RE: EPA Industrial Emissions Licensing Application P1181-02

On behalf of the applicant, Amazon Data Services Ireland Limited, and further information requested 5 September 2025 by the EPA, we submit further information and clarifications in respect of the licence review application P1181-02.

Sheet 3 - Marley's Lane - Drogheda Boys Pitches/St. Nicholas GFC - Rathmullen

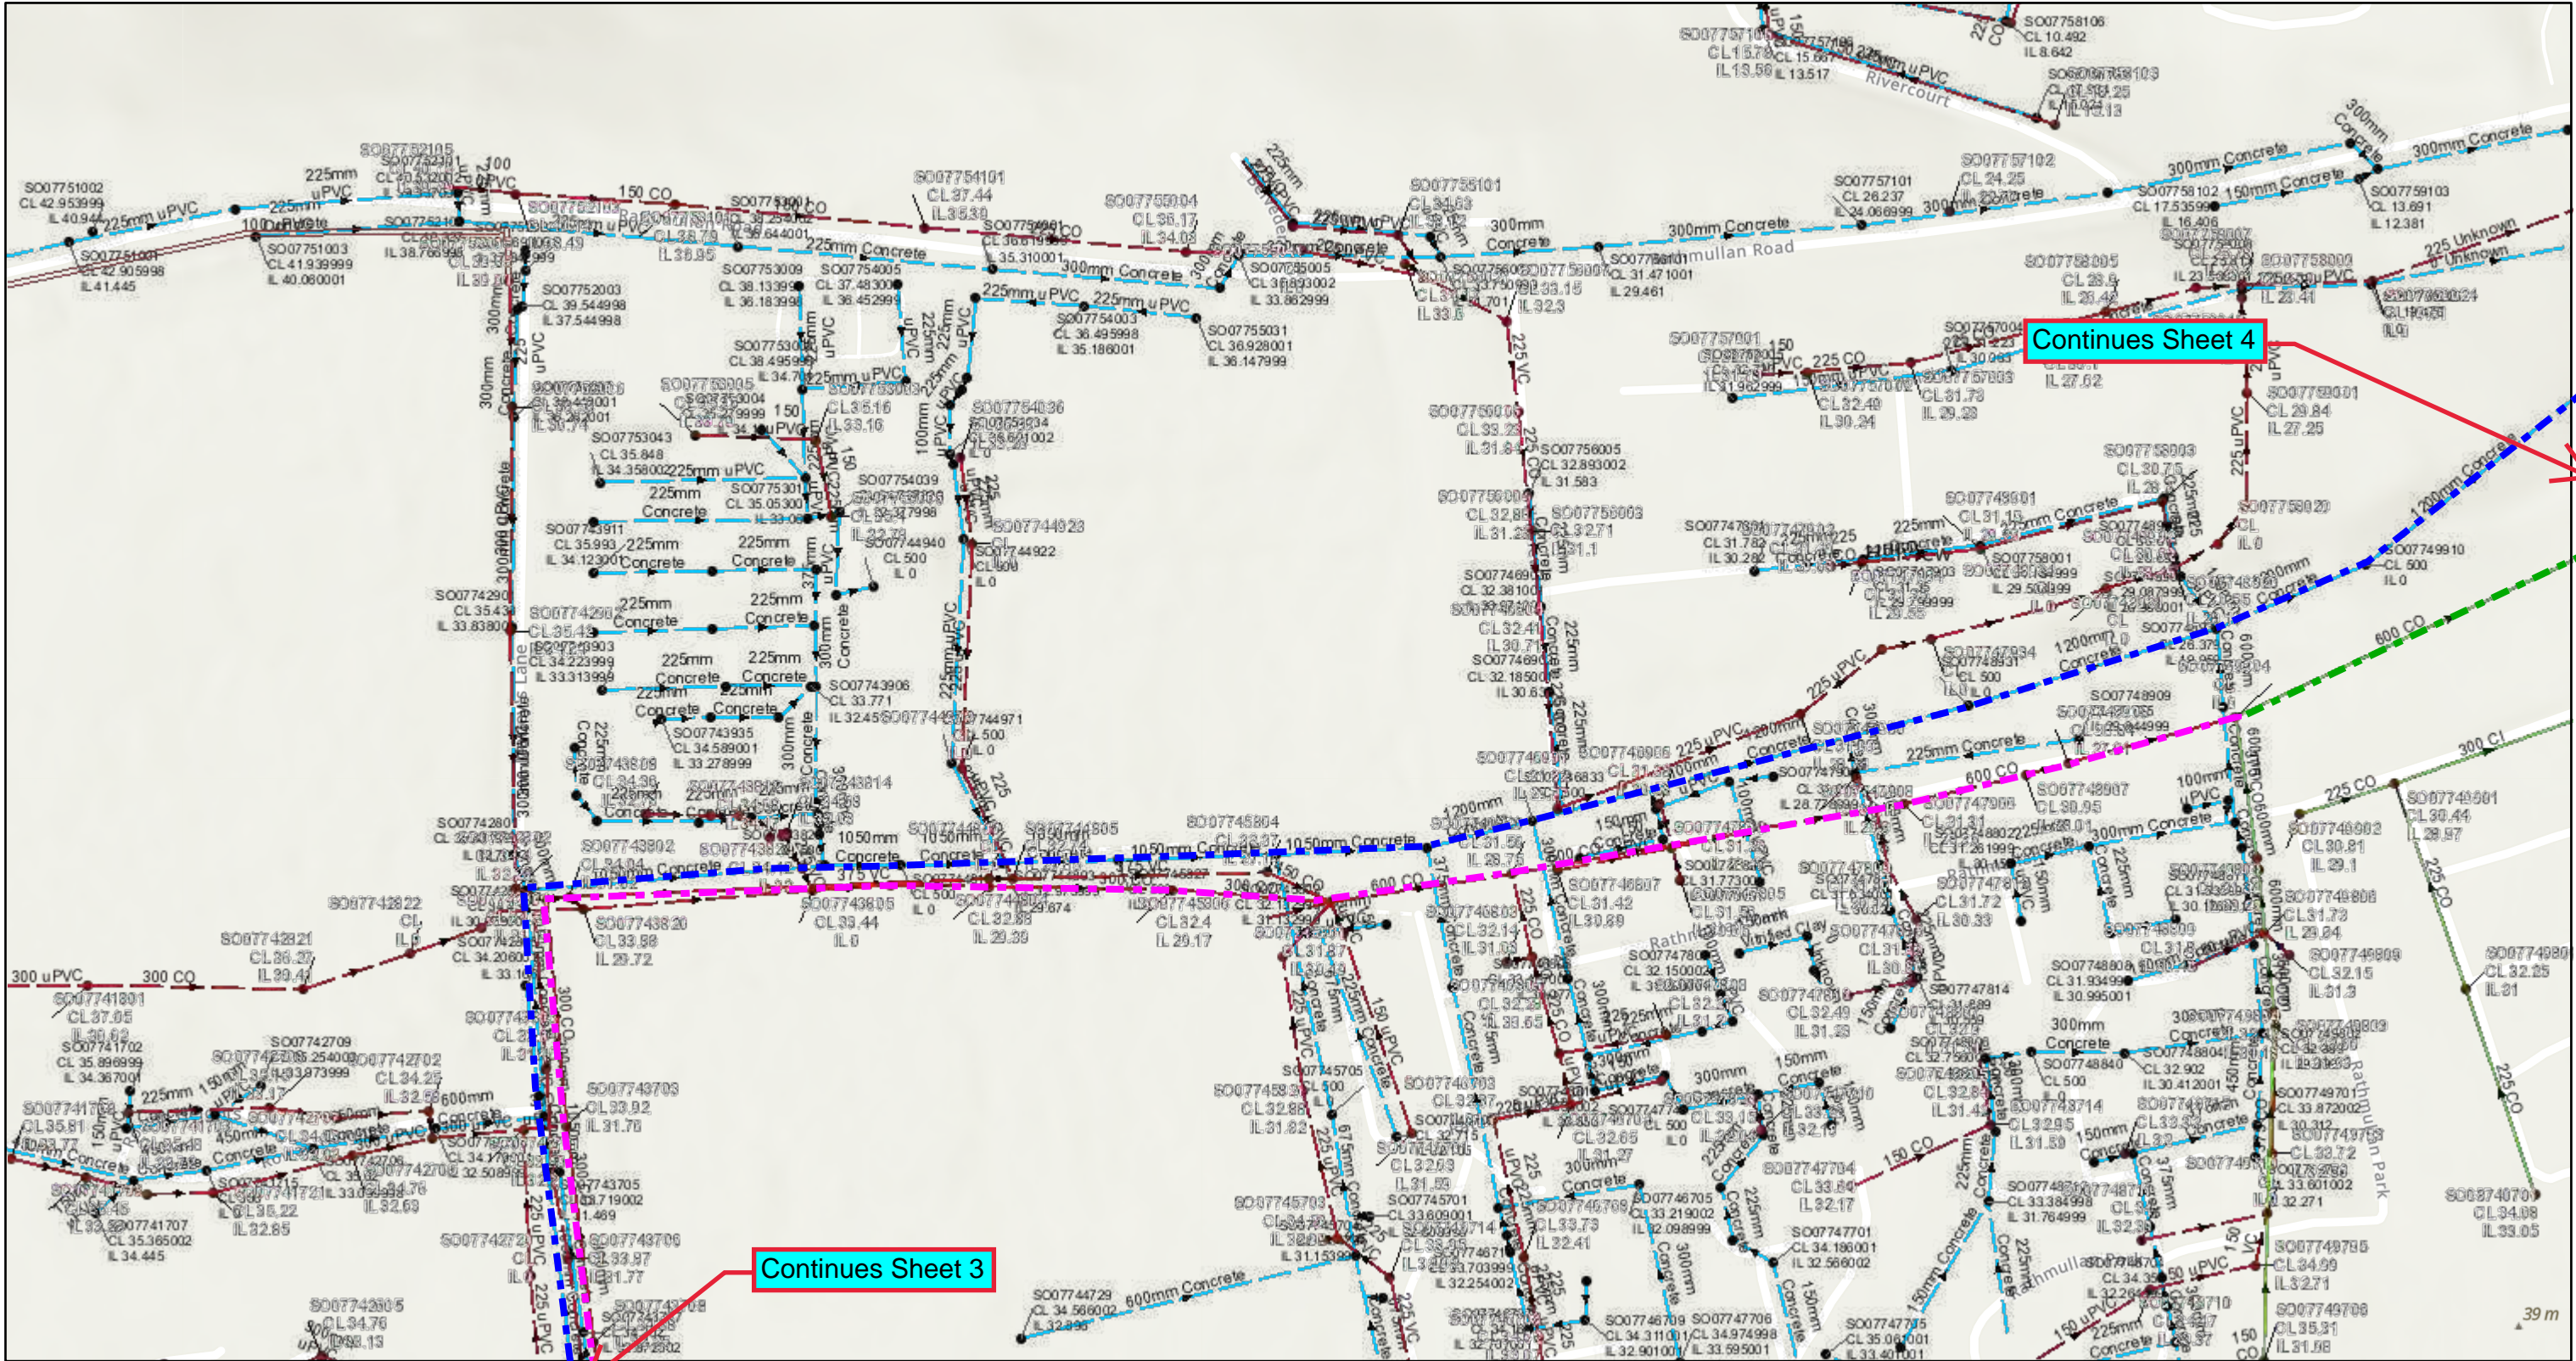
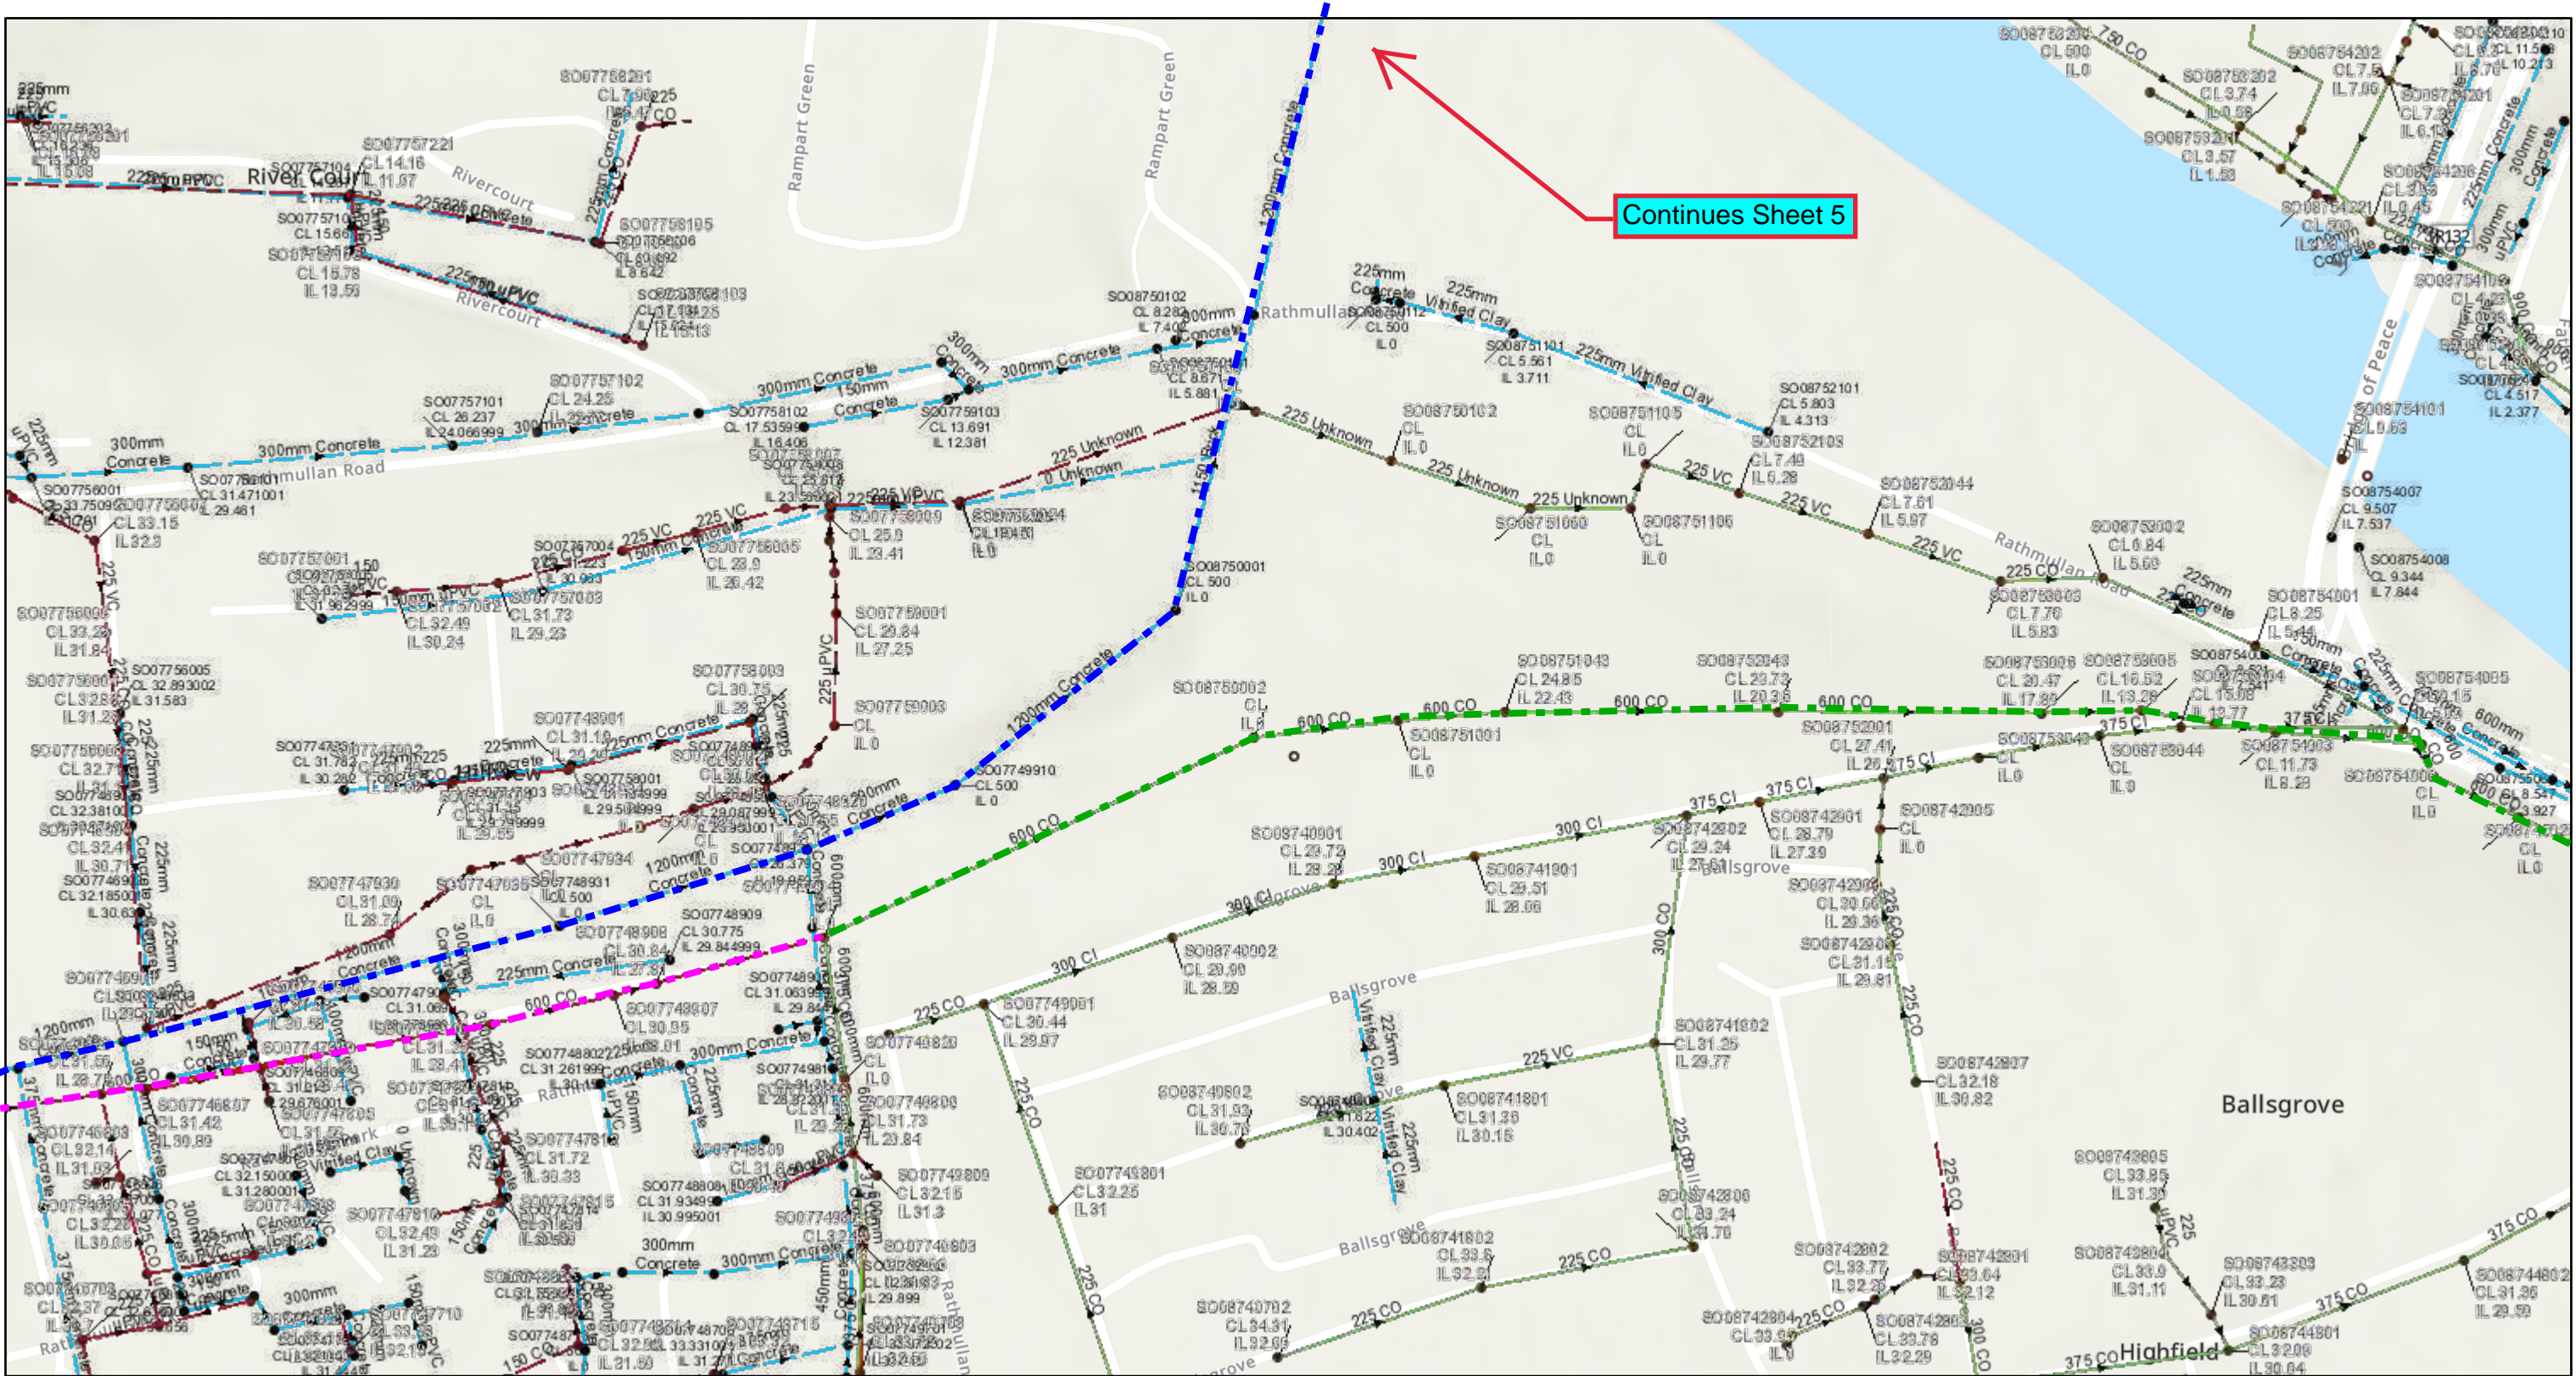
- Obtain, from the IDA, the exact location of the outfall of the IDA storm water network into the River Boyne, currently stated as 'not known' (Attachment 7-1-3-2 Surface Water and Ground Emissions Impact Assessment) to confirm storm water is discharged to where it is 'assumed' to discharge.

The storm water outfall location is shown in Appendix A. The drawings show the surface water drainage route from the IDA Park to the outfall located close to the Ramparts / St Dominics Park, approximately 1.5 km to the northeast of the site.
